ECR/Documents for Information and Approval

Giulia Romagnoli and Natalya Kahn for BE-EA, 2024-03-12

ECR for Approval

SPSX-F-EC-0005
Version **0.2**

Figure 2: Planned alterations [3].

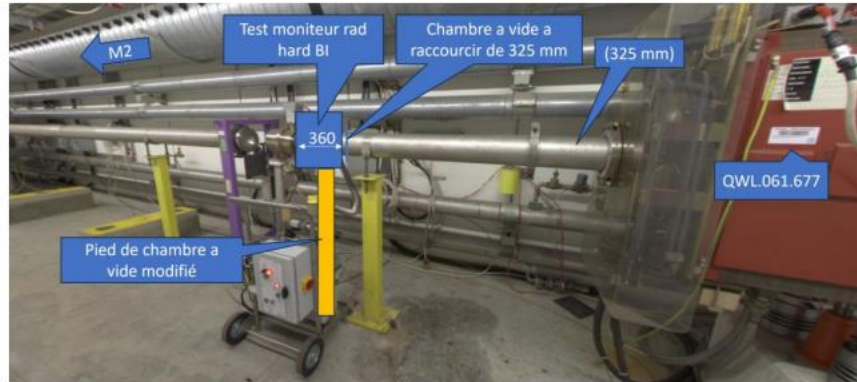
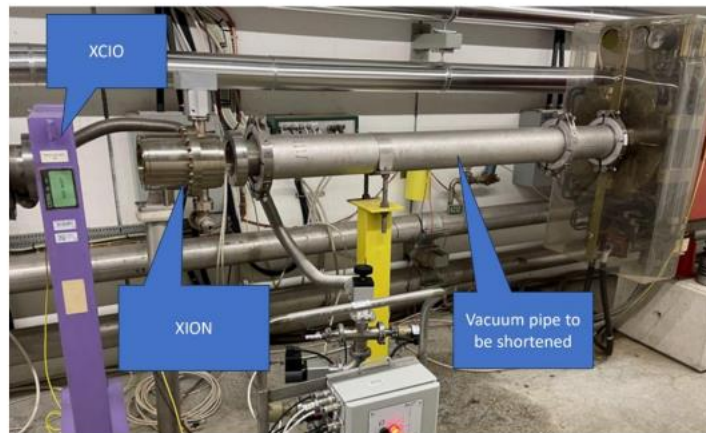
a 2×10^{11} p/spill user requirement is mentioned in [EDMS 2719043](#). How does this compare with the present scope ?

The ECR should be checked/validated by Survey & Alignment team (BE-GM).

3D integration models are missing, have these modifications been validated by integration team (ICEA) ?

As the layout is affected (shortened beam pipe), 3D integration drawings must be updated with the profile monitor model.

The aim of the prototype is to test the fibres under high particle flux. It's not an operational device: so an alignment error of the tank by a couple of mm is not a big issue for the study.

Figure 2 — Position of carottage below rack RA1518 in B.889 R-007.

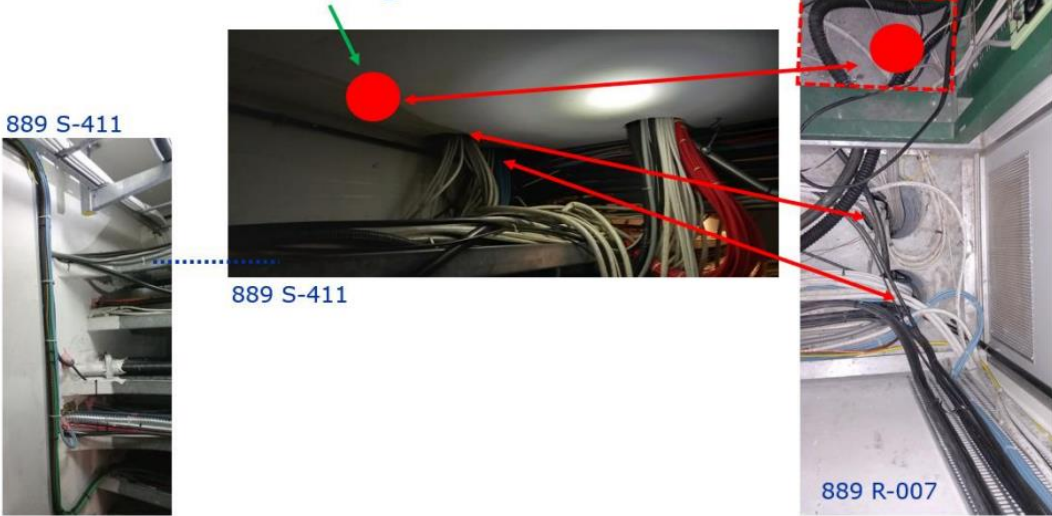
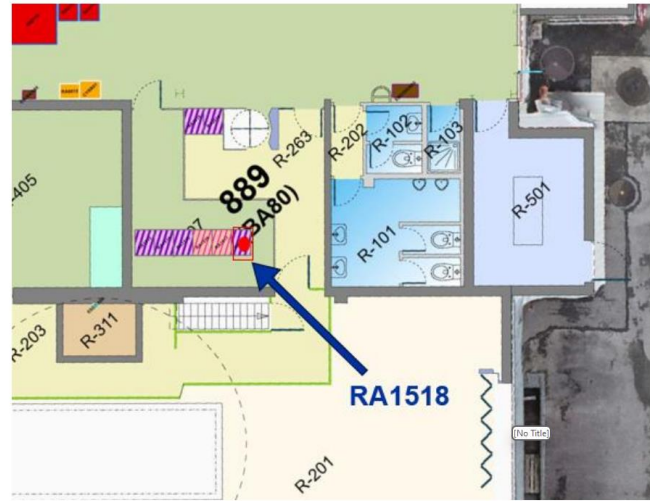
⚠ **Accepted with Warning** by **BALTASAR DOS SANTOS PEDROSA Fernando** (EN-ACE)

The core drilling has been performed already in January 2024

Figure 1: Photographs of the **XBPF** (left) and the **XBTF** (right).

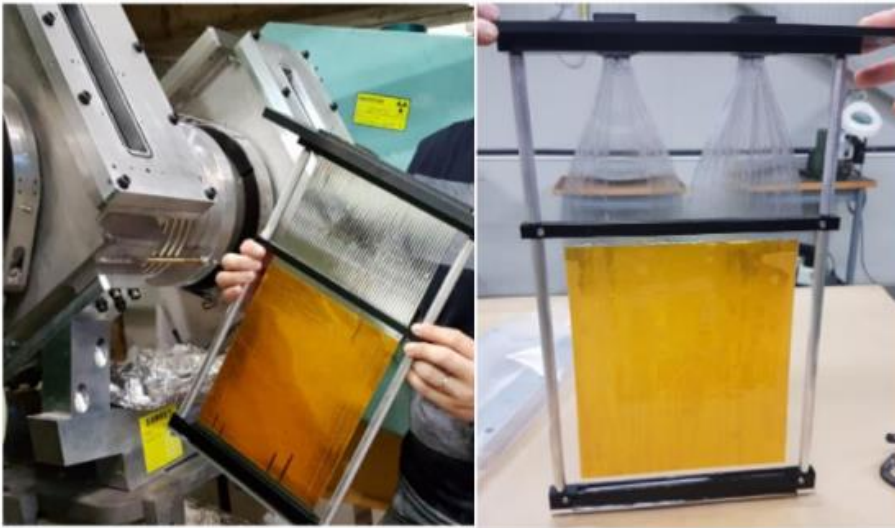
We must check if we have sufficient information to decide the design solution for the supports, which shall be compatible with the survey requirements, and the integration constraints.

I think that BE/GM should be added to the checkers list.

It would be good to have the justification mentioned in the document for the required precision.

Now that both Phase-1 and Phase-2 budget of NA-CONS has been approved (MTP 2023), it is important to clarify the alignment strategy and corresponding mechanical support requirements as these may have an impact on the already approved budgets

Figure 4 - BA81, 890/R-001, RA9922.

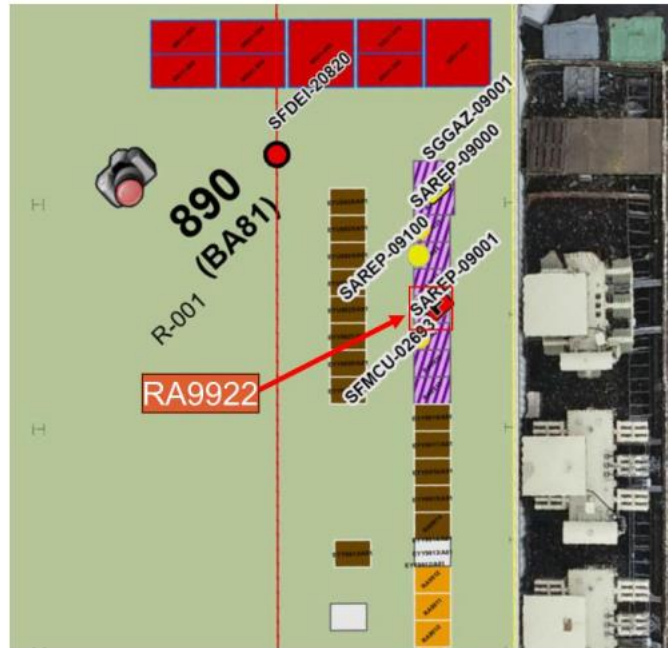
Request checked by main stakeholder (SY-EPC for BA80 and BA81 and BE-EA for EHN1). In the case of BA80, please seek validation from ICEA. As a matter of fact, BA80 toilets will be modified this RUN to host the underground fire detection system. Have you envisaged the possibility to merge with them ?

- For RA1518 in BA80 (887/R-007): Position validated during ICEA#29 (see comments in the minutes).
- For RA9922 in BA81 : Position not presented/validated yet during an ICEA. The integration study of the whole BA81 will be in phase 2, and implemented during LS4. So I see no showstopper to keep your rack and make a consolidation during LS3. Note that depending the BA81 integration study, this position might change. But still to present it to an ICEA.
- For the two cases in EHN1:
1/ Salève side, to keep the same position is OK, but the false floor could be removed during the "false floors and barracks" study which will be carried out during phase 2 of NACONS. Maybe worth to evaluate if we could already remove the false floor.
2/ Jura side: OK to keep the same position.
